Attachment to letter dated January 4, 1979
L O Mayer, NSP, to Director of NRR, USNRC

NSP Responses to NRC Concerns Contained in Enclosure (2) of T A Ippolito's letter dated November 24, 1978

NSP Responses to NRC Concerns Contained in Enclosure (3) of T A Ippolito's letter dated November 24, 1978

PF-3 Electrical Cable Penetration Qualification

FIGURE 1

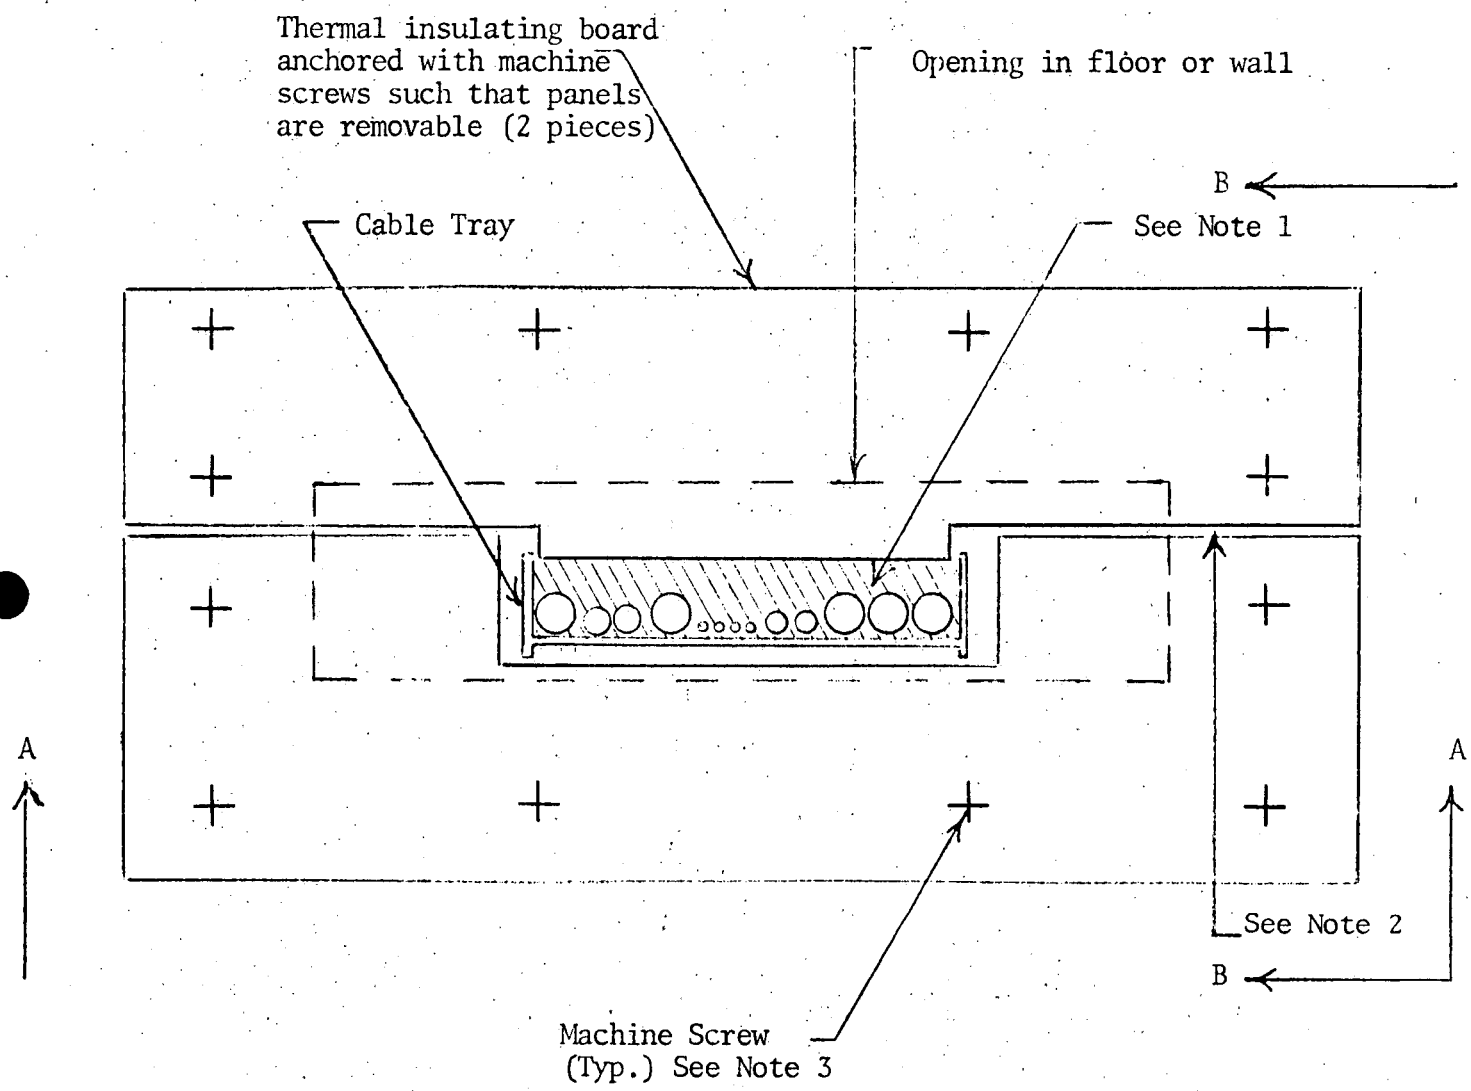
Descriptions of each type of electrical and mechanical penetration seal that is used at the plant are shown on the attached figures. The materials which are presently used are:

The figures depict the present day method of penetration sealing. Penetrations which were sealed previously are similar in design except that polyurethane foam was used in place of Kaowool to fill voids. This foam has the trade name Insta Foam Froth Pak and was manufactured by Instafoam Products, Inc. All penetrations containing polyurethane foam have been sealed with a minimum thickness coating of 1/4" mastic.
